USNRDL-TR-582  
17 September 1962

DESIGN MODIFICATIONS AND 1962 COST ANALYSIS  
FOR A STANDARDIZED SERIES OF FALLOUT SHEILDERS

by  
Lewis G. Porteous

prepared for the  
OFFICE OF CIVIL DEFENSE  
DEPARTMENT OF DEFENSE

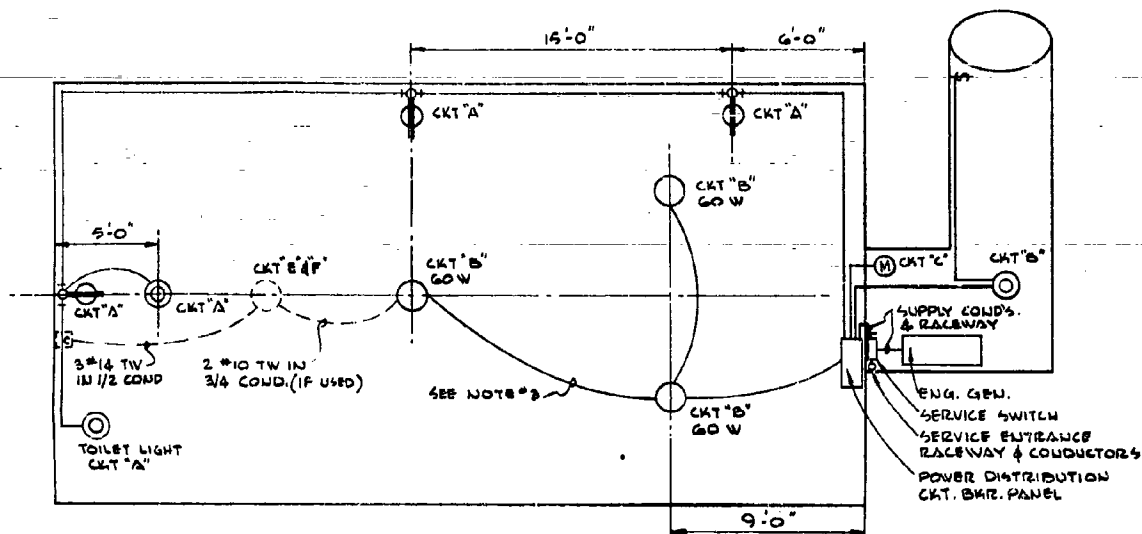
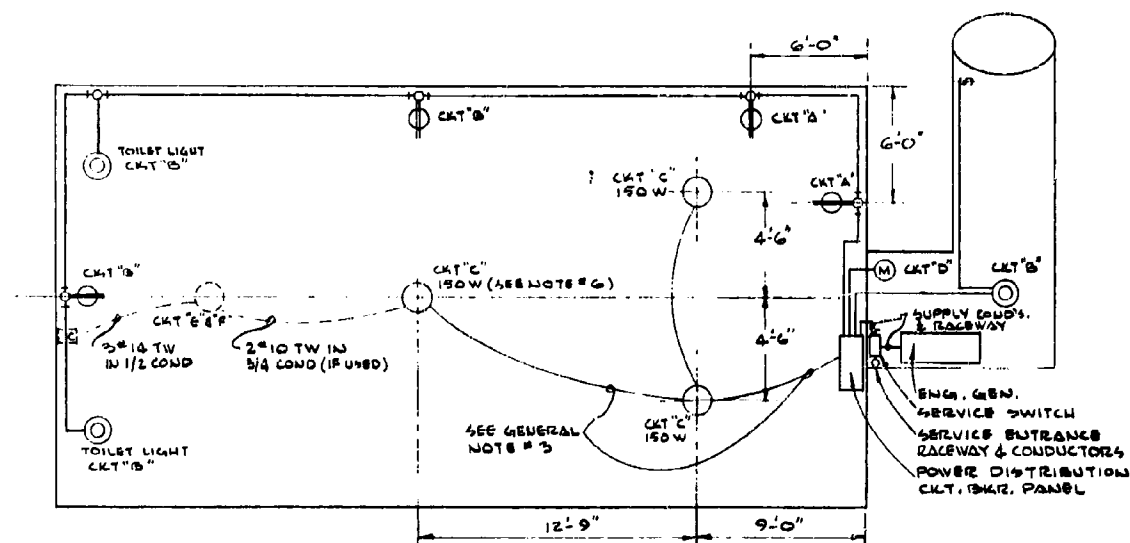
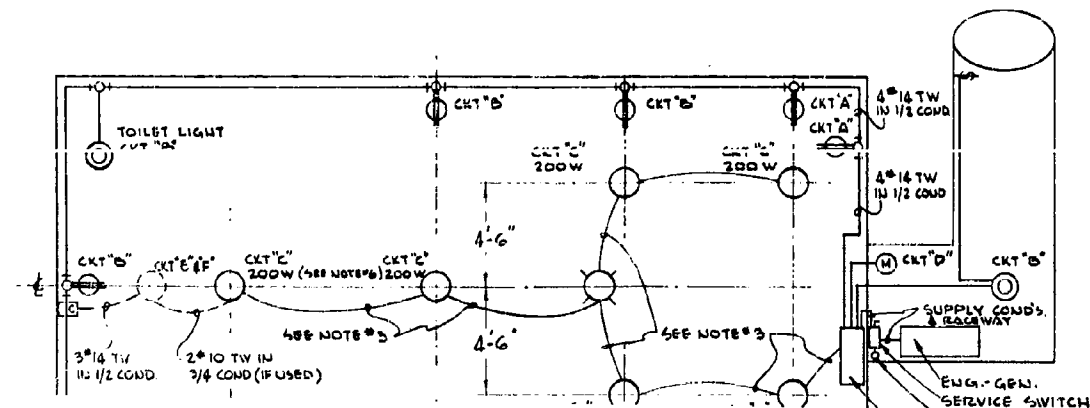
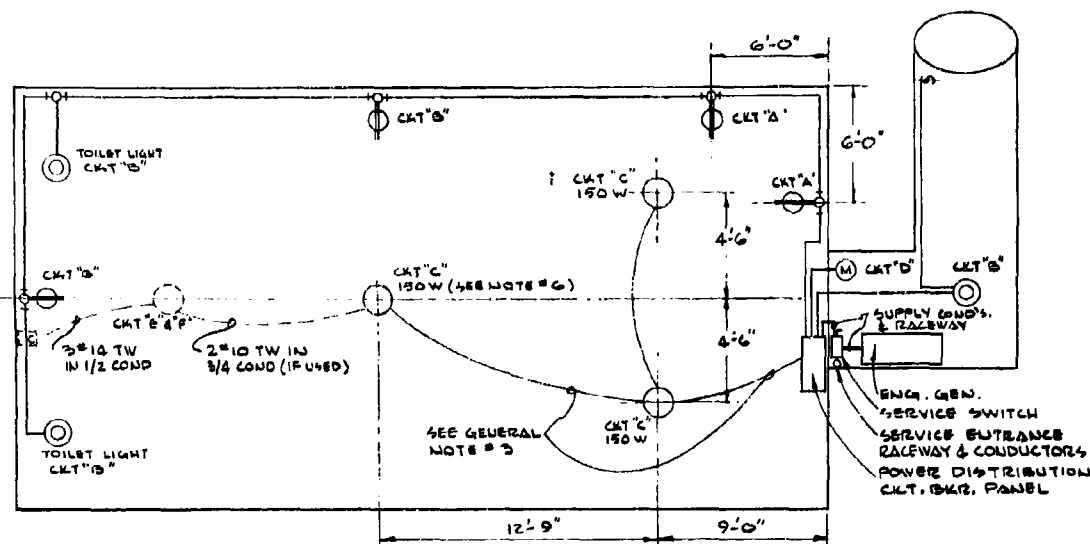
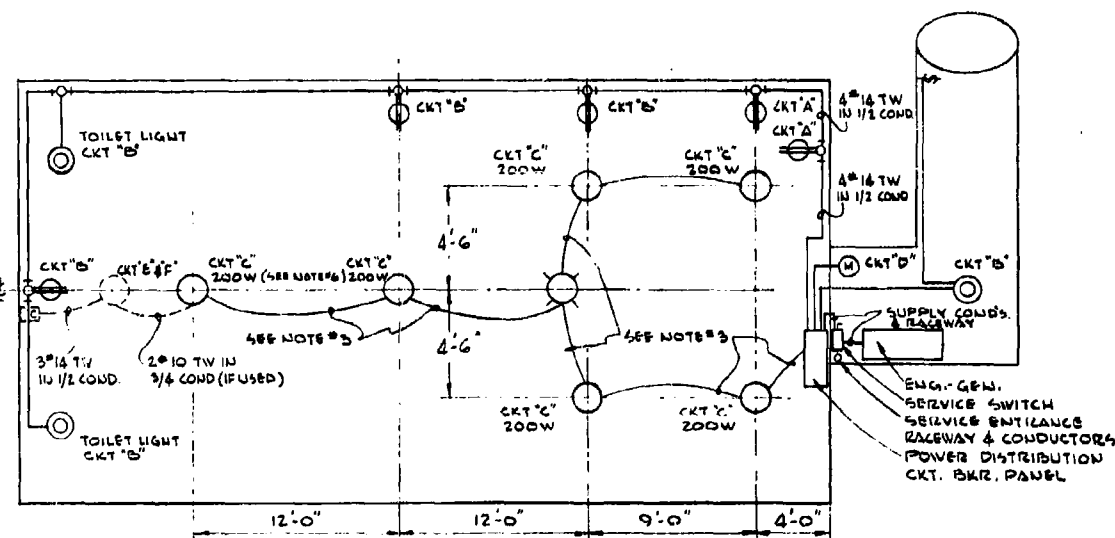
The design of the electrical lighting and power system of Ref. 1 has been modified as shown in Fig. A-12N. The design was dependent on the maximum electrical load that would result when the electric equipment specified in the various shelter packages were energized. Governing equipment were lighting, control equipment, food immersion heater, hot plate, vent fan, and air conditioner. A study of the probable combination

of the shelter packages indicated the need for three separate electrical lighting and power distribution systems, as shown in detail on Fig. A-12N as Arrangement A, Arrangement B, and Arrangement C.

The electrical items required for various combinations of ventilation and hotel packages have been grouped into 6 electrical packages: M-1 to M-6. All the items are described in Table 25, the items in a given electrical package are listed by number in Table 27, and the electrical package for a given combination of ventilation and hotel packages is specified in Table 28. Figure A-12N gives the installation arrangement of electrical items.

**FIG. A-17M**

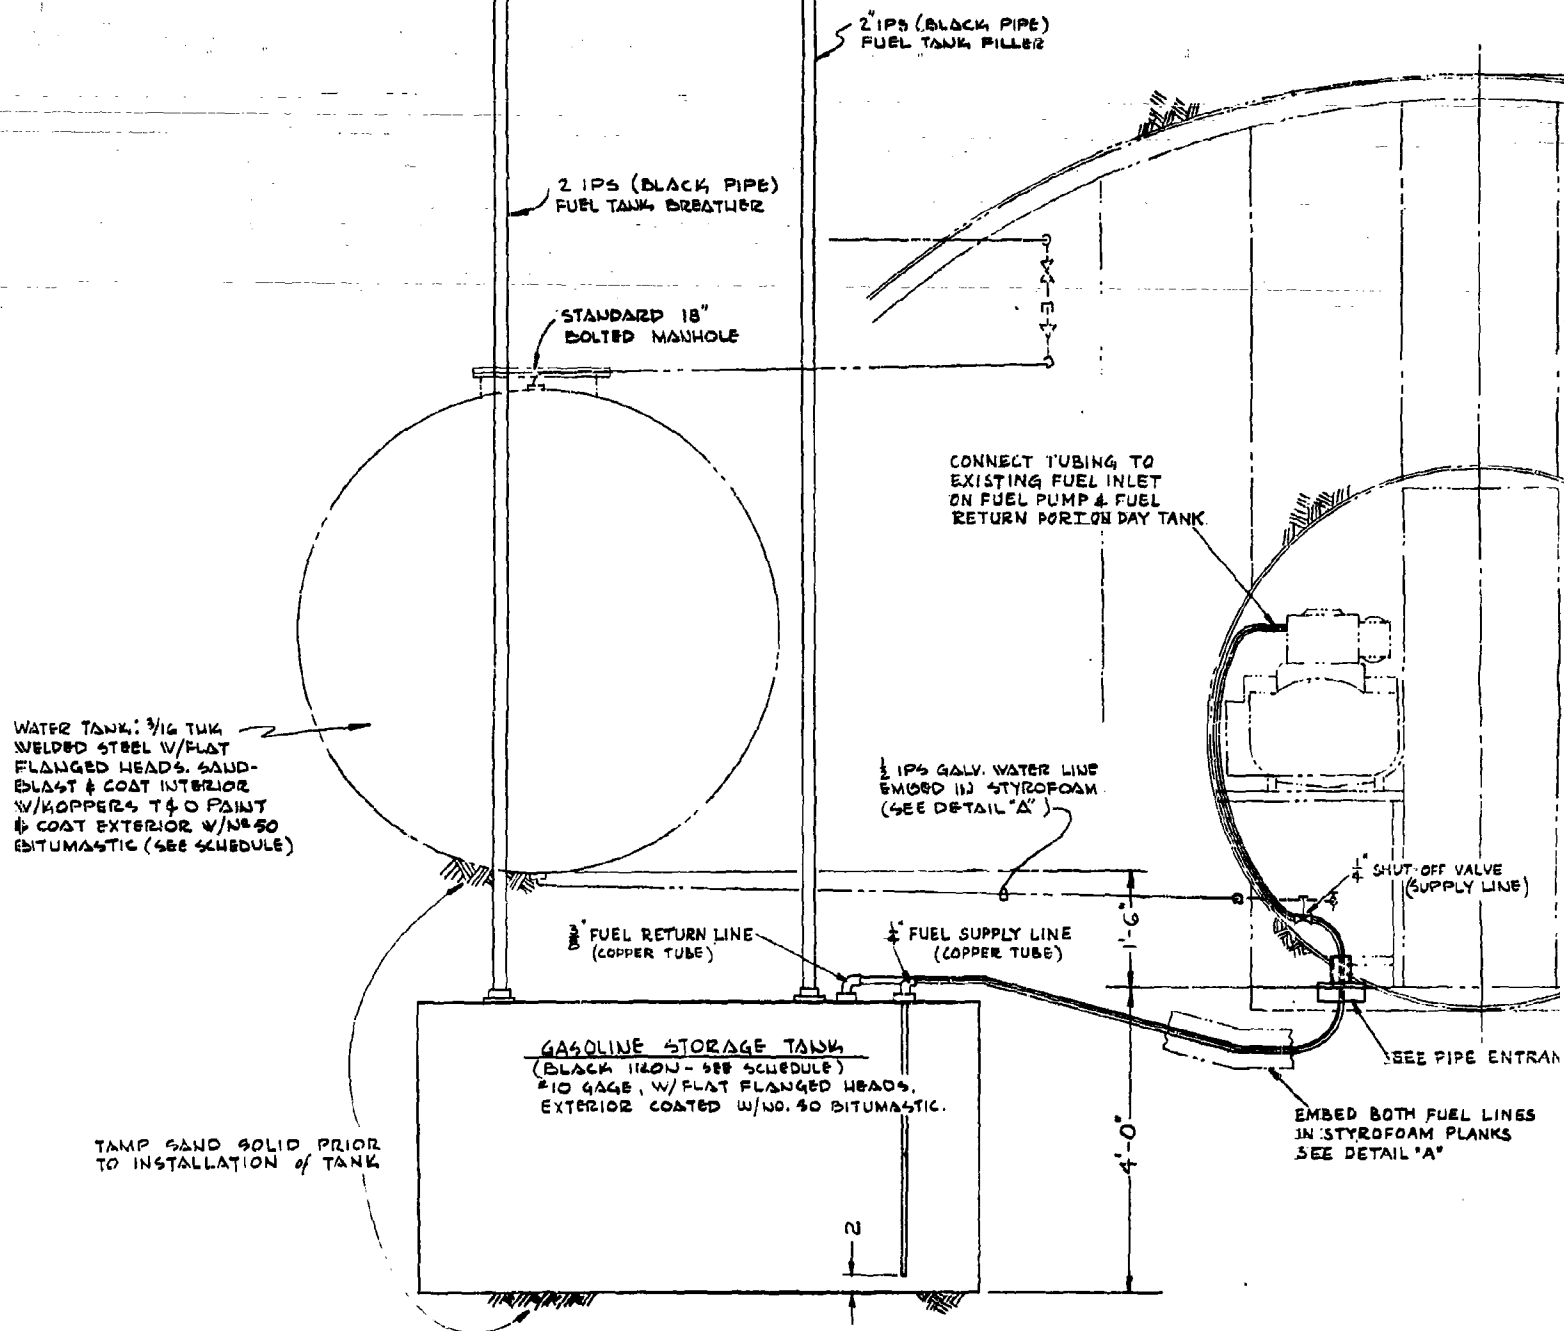
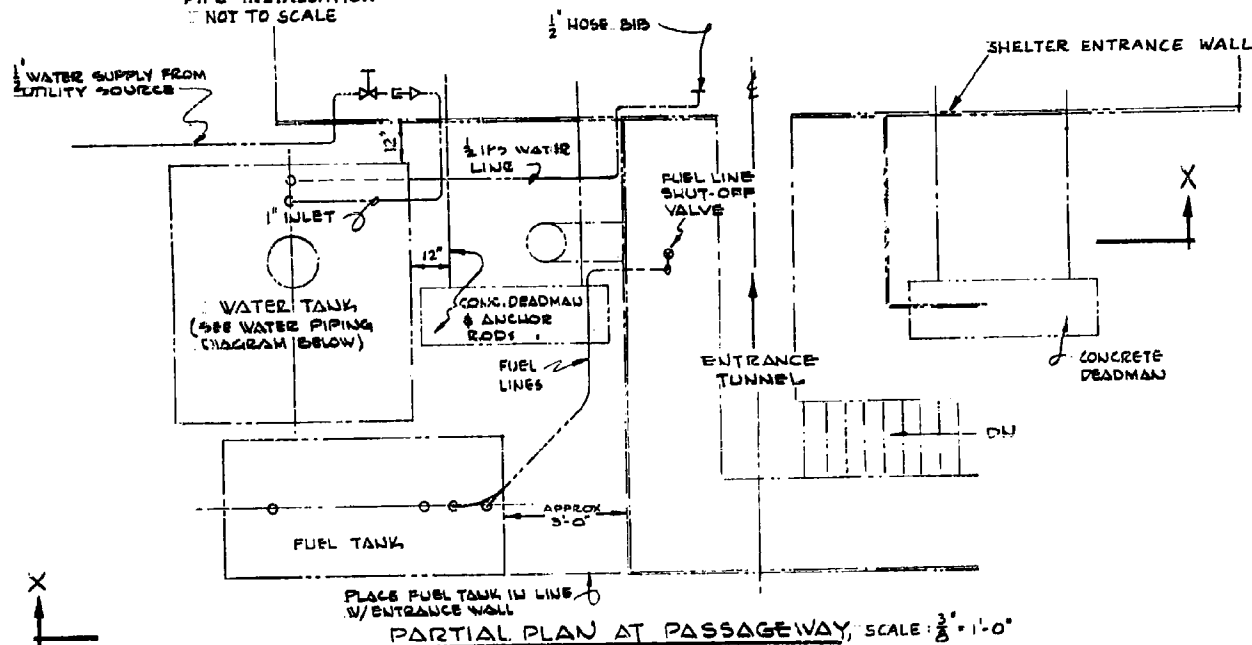
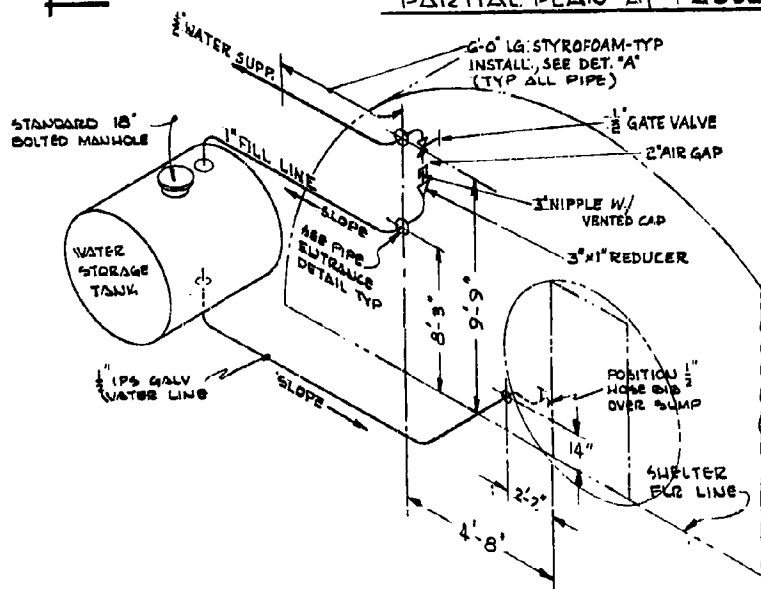
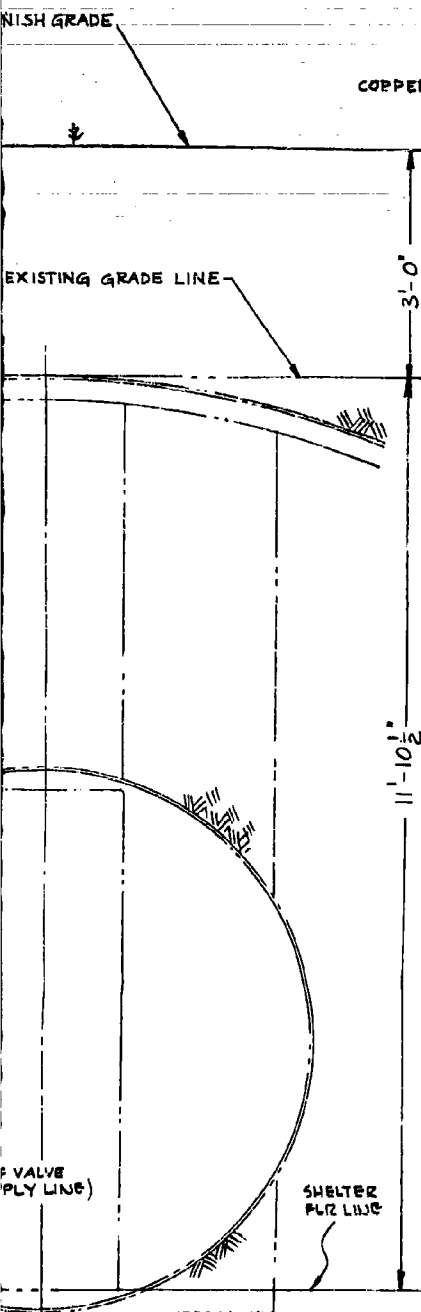
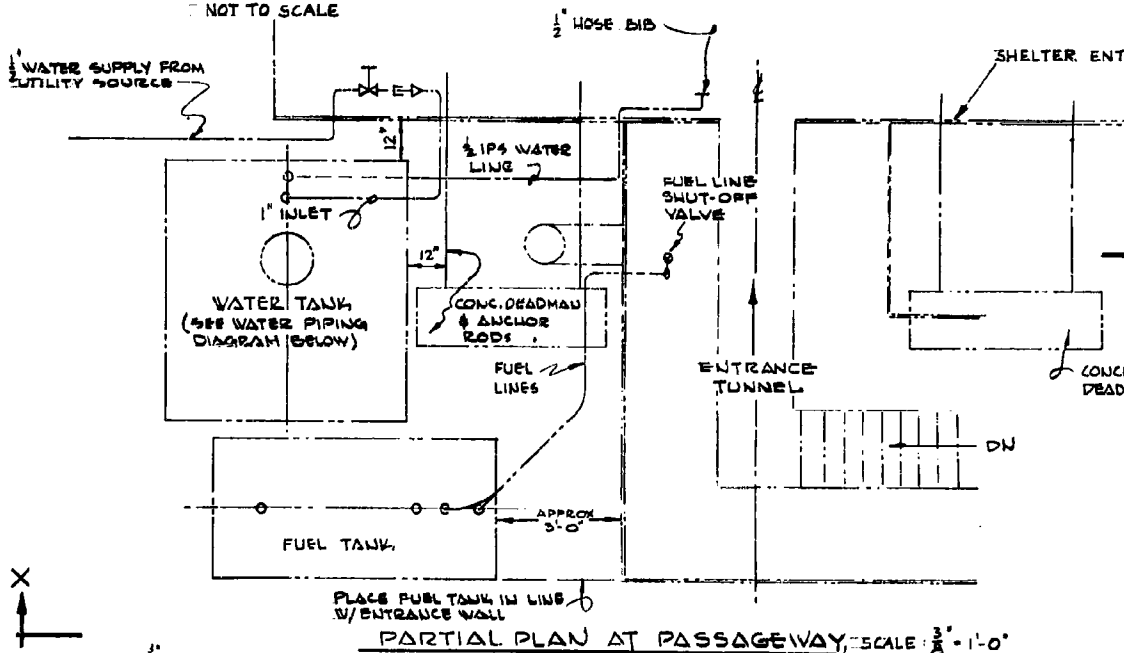
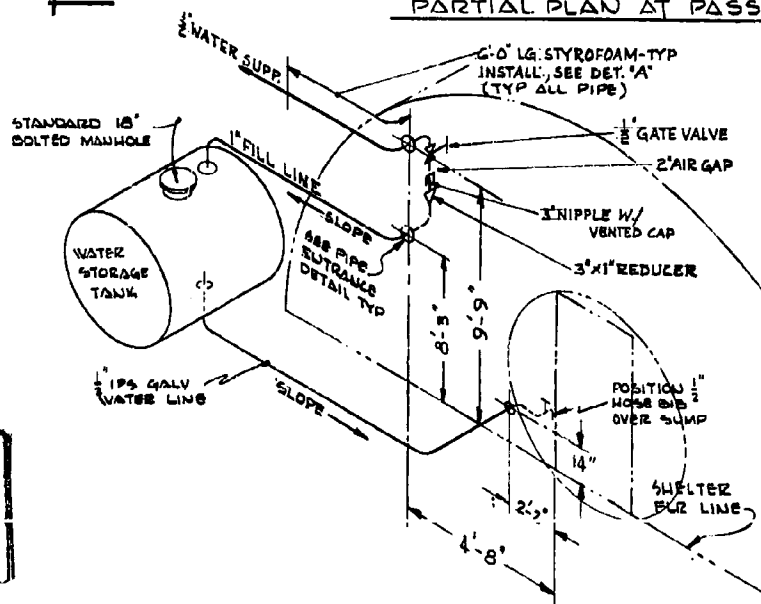
The design of these tanks has been modified to decrease their cost without affecting their performance in the intended environment. See Figs. A-11M and A-17M.

The fuel tanks have been modified to get more efficient use out of the basic sheet metal stock as "provided to the fabricator by the steel manufacturer." Also, the dished tank heads specified in Ref. 1 have been replaced by flat, flanged tank heads. Both changes will result in considerable savings in tank costs.
